# UDPA Building A + Open Space

4530 12th Ave NE, Seattle WA 98105 SDCI# 3034749-LU

# **NORTHEAST DESIGN REVIEW BOARD:**

Design Review Recommendation Administrative Design Review September 2, 2020

# 2.d.i - Response

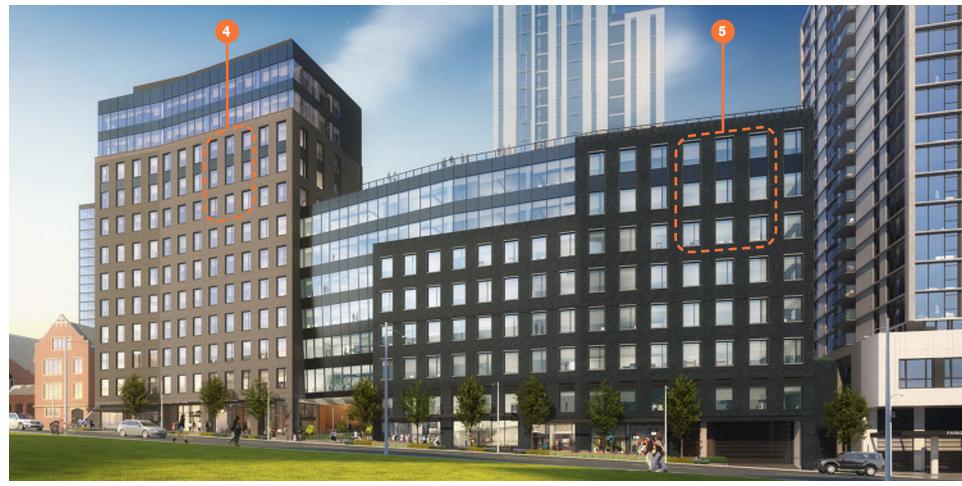
- Improve the continuity and wholeness of the overall building expression, as currently the pieces appear to be conflicting and independent of one another.
- Achieve greater continuity by using the idea of the portal or midblock void to inform the façade systems scale of openings to be more responsive to program, exposure, and massing moves.
- Refinement should address the starkness between the two expressions and provide greater depth at transitions.

- The curved site informs a series of flowing segmented facades with a maximum length of 80'. The masonry clad tower mass modulates in height per zoning requirements to imply three distinct masses with a break mid-block. The masonry masses terminate with a perceived double height opening at the top.

- The distinct masses are connected with a secondary facade creating ample changes in depth and plane. The changes in plane break down the mass and focus attention on the mid-block

- All elements of the tower are woven together with ribbons of opaque panel which compliment the masonry.
- Vertical mullions align with masonry openings. The window wall feature caps the upper floors and slopes inward towards the pedestrian mid-block, guiding the viewer in.

- The masonry windows feature brick trim at the head and sill which projects 1" from the face of the wall and alternates in color to unify the midrise and highrise component. The trim in the midrise matches the typical wall brick of the highrise, while the trim in the highrise matches the typical brick of the midrise.

# 2 SECTION PERSPECTIVE OF CONNECTOR

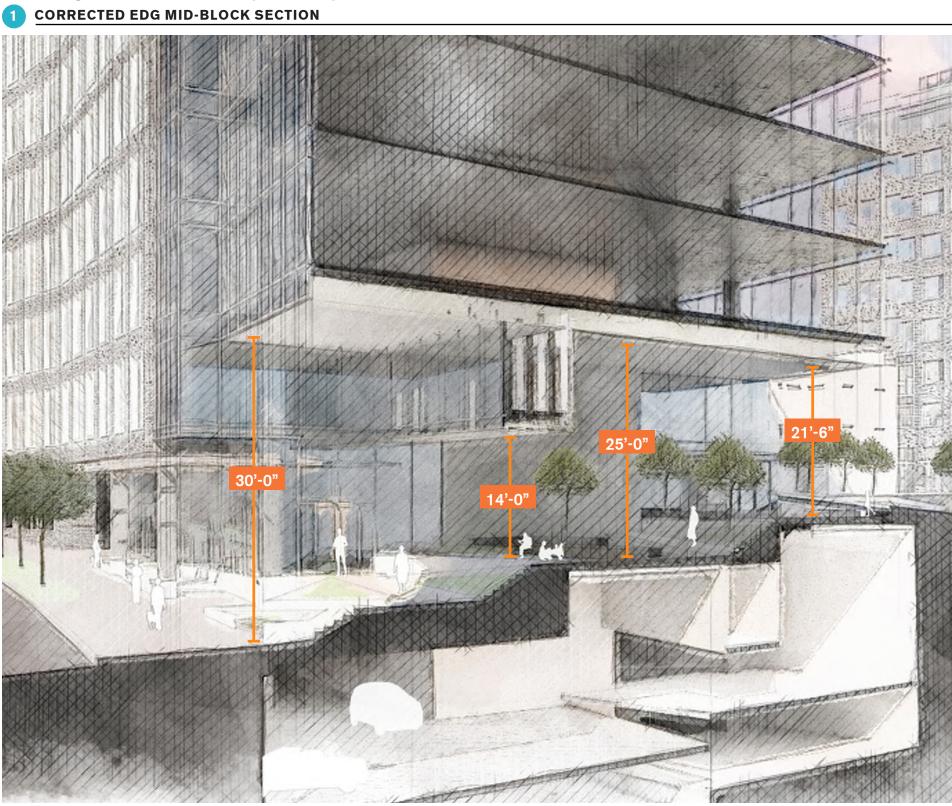
- Remove or revise the circulation bridge spanning the mid-block connection as currently it seems to interrupt and diminish the grand gesture of the void.
- The Board noted the bridge could be there but only if it becomes a unique element of the mid-block more so than the façade, perhaps seeing over or through it, maybe becoming diagonal, or by another means of integrating the bridge into the overall mid-block vocabulary.
- Currently the bridge creates too much compression at the void entry.

- The occupiable portion of level 2 above the **voluntary** mid-block connection has been integrated into the rest of the building as part of a holistic expression. Beginning at level 6, the western wall of the mid-block gently slopes inward, drawing visitors to the mid-block from afar. This is a conscious massing move in order to fully integrate the connector connection with the rest of the massing.

- The soffit above the mid-block is a slightly sheened metal panel with integrated down lighting and is continuous into and through the lobby in order to stitch the street level design into the overall mid-block expression. The massing connects the window wall portion of the tower into a holistic expression all the way through the lobby space. The soffit no longer appears as a pinch point but as an extension of the lobby into the exterior space.

- The mid-block design was also widened at the opening at ground level along the north wall to provide a more grand gesture.

3 VIEW OF MID-BLOCK CONNECTION FACING EAST

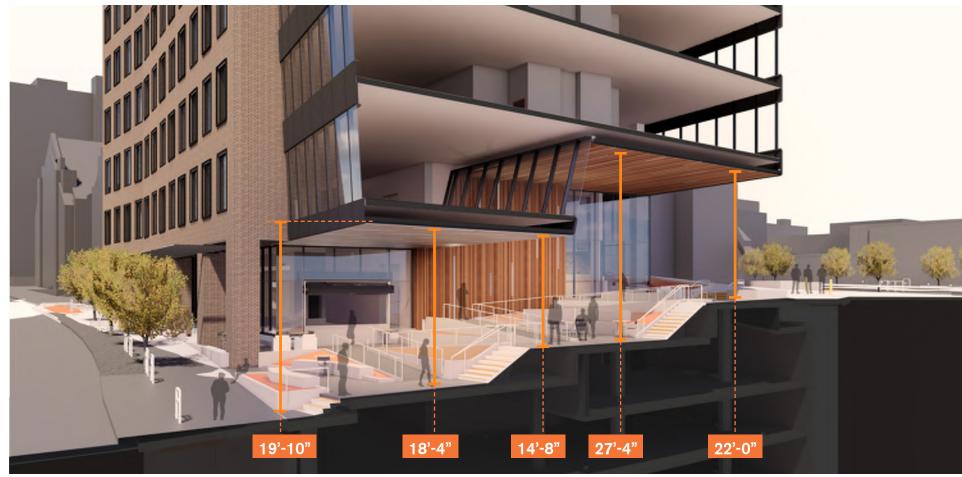
- As noted above, the Board was concerned with the pinch point created by the circulation bridge. Moving forward, this should be resolved to create a grander gesture and stronger sight lines through the mid-block.
- In addition, a section through the space with accurate height dimension should be provided at the next meeting.

- The central core wall and soffit are featured in a wood cladding with clear sight lines from the open space and from 12th ave.
- The soffit below level 2 in the mid-block has been fully integrated into the lobby to create a continuous space both inside and outside in a grander gesture that incorporates with the massing.

- The level 2 floor area, required as a means of egress, is consolidated to the western portion of the facade so as not to impede the ceiling height of the central spill out area. The glazing slopes on both the East and West to soften the mass, guide visitors into the space, and create a focal element in the center seating area.

- Sight lines are clear when entering the mid-block from either the East or West. However, the primary focus is the central space and the seating areas.

- Circulation within the mid-block has been reconfigured to maximize the height in the seating areas.

# 2.d.vii - Response

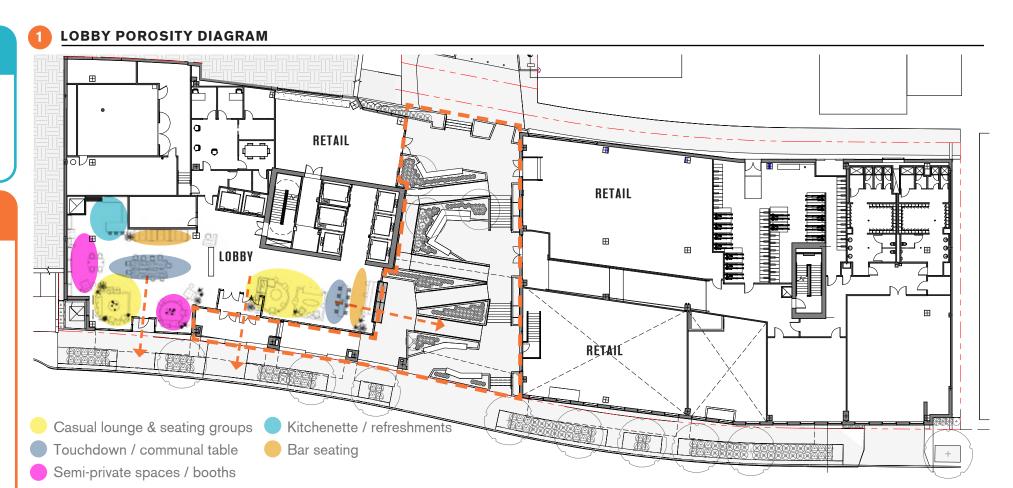
• Provide more detail on how the lobby will be programmed to be active.

• The interior design of the lobby will be activated by building circulation and interior design. The intent is to relate the office lobby to the mid-block connection by continuing similar materials from the mid-block to the office lobby. The primary ceiling element in the lobby is continued above the mid-block to maintain a holistic expression of interior and exterior. Similarly, the central core is wrapped in a wood wall finish which is also continuous both interior and exterior. The south portion of the lobby features a large operable wall system and bar height seating to promote a direct physical connection. The north portion of the lobby features an intimately scaled area consistent with the neighborhood intended for casually working or meeting and with the potential for direct access to 12th ave. Lastly, the upper level lobby has been removed and replaced with retail to help further activate the alley and mid-block connection.

#### STREET VIEW FROM 12TH AVE NE FACING NORTH

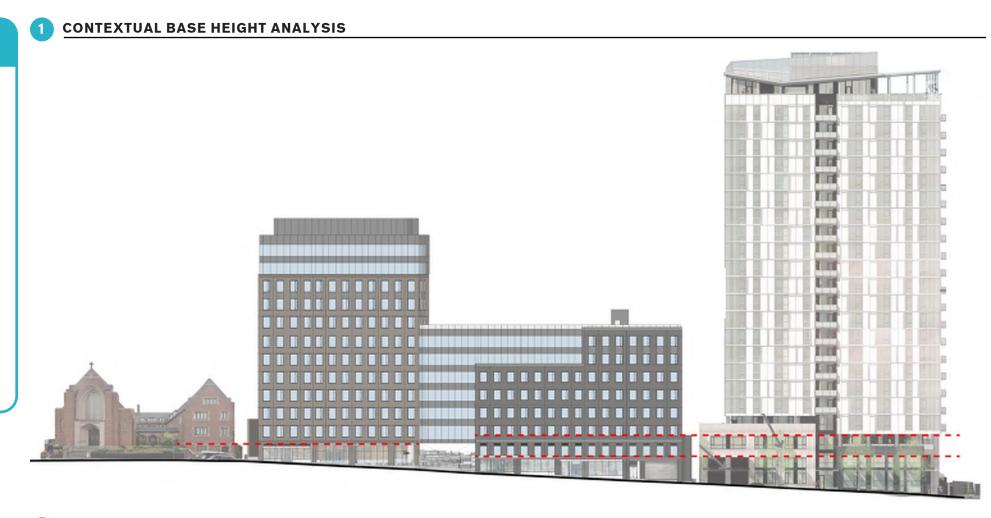
- Further consider contextual cues and horizontal datums at street level, especially south of the mid-block connection. The Board noted there are strong contextual historical horizontal datums that could be picked up to lift the building up and make the base more porous, or pulled back to relate to both neighborhood cues and relate back to the base expression north of the mid-block connection.
- Related to the above guidance, the Board would like to see studies of the base height at the next meeting.

- The street facing facades maintain a horizontal datum of inset soldier course brick at the second floor level with a distinct approach to fenestration below. The band registers with the top of the retail at the South corner of the block. The intent is to increase openness and glazing for the retail to the south of the Mid-block connection, while also aligning with prominent adjacent datums.

- The retail facade is composed of larger openings at street level and the windows immediately above are articulated with louvers at the head. The scale of the openings above the retail are differentiated by providing a 1" projection of brick trim at the top and bottom of all the openings.

PROPOSED MID-BLOCK DESIGN

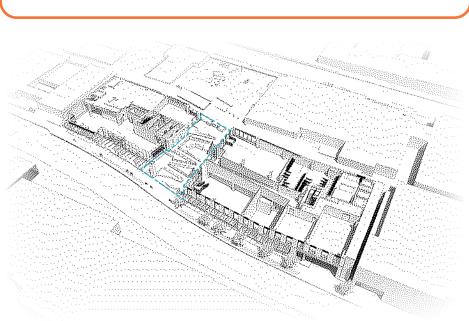
Provide flexibility for spill out. Mid-block connection looked a bit constrained by ramps and steps. Strongly encouraged spill out spaces or larger operable windows to create more porous edge. Ensure the mid-block connection is an active space rather than just a pass through.

- The lower level lobby massing has pulled back, creating more opportunity for movement and seating. Ramps have been reorganized (3 segments as a U, then one scissor) and steps have been straightened and regularized.
- These changes created four spaces to inhabit (lower, lobby, middle and upper plazas) that feel connected to each of the retail and lobby uses, maximizing vibrancy and activation of the spaces.

# 5.b - Response

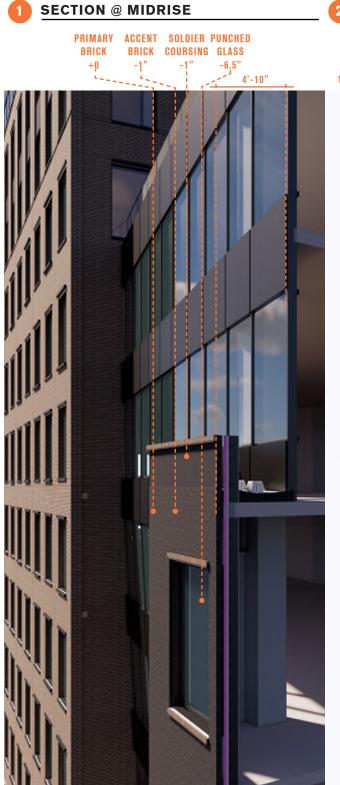
• The Board noted greater dimensional change should be used between material changes

- The façade has been simplified to more clearly reflect the massing. The brick façade now encapsulates the corner and accentuates the difference in depth between brick and glass.
- The horizontal change in plane between the brick highrise facade and the window wall varies, but is always greater than 5'.
- The vertical change in plane between the brick and window wall is typically 1'-0" with extra depth added on the south side of the mid-block entry along 12th Ave up to 4'-10". The transition between brick to window wall is highlighted by a double height soldier course.
- Moreover, each masonry window opening is setback 6.5" and is framed in brick trim extending 1" from the facade of the surrounding brick to create added depth along the masonry facade.

2 VIEW OF ACTIVATED ALLEY

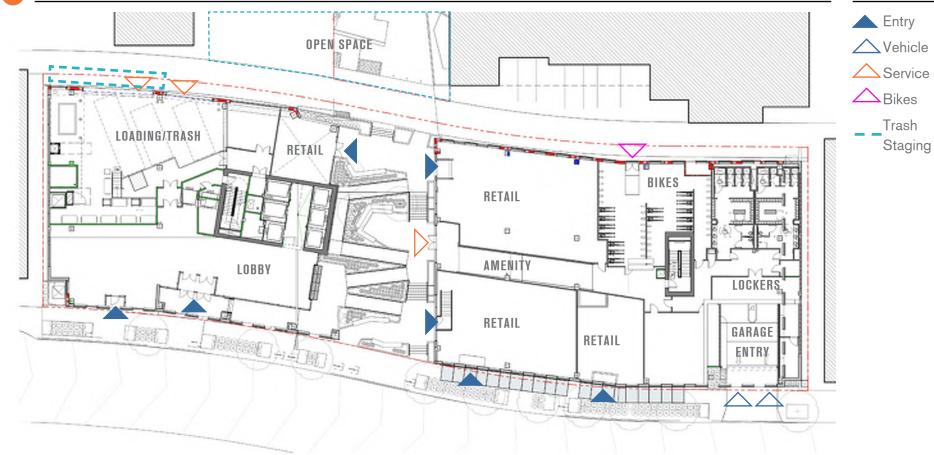
Mitigate Garage Entry Impacts & Provide Service Use Diagrams for Circulation & Trash Staging

- The parking entry is recessed from the primary building frontage. The adjacent wall to the North was also recessed to increase visibility of the sidewalk for cars exiting the parking area. The visible walls at the parking entry are a consistent brick material with the rest of the façade. The parking entry is secured with a high quality perforated metal screen overhead coiling door.
- The loading dock and trash staging area is located on the northeastern façade and fully serviced from the alley. It is located behind an existing building, and to the greatest extent possible, visually screened from public view of the park both in location as well as with overhead doors and planting.
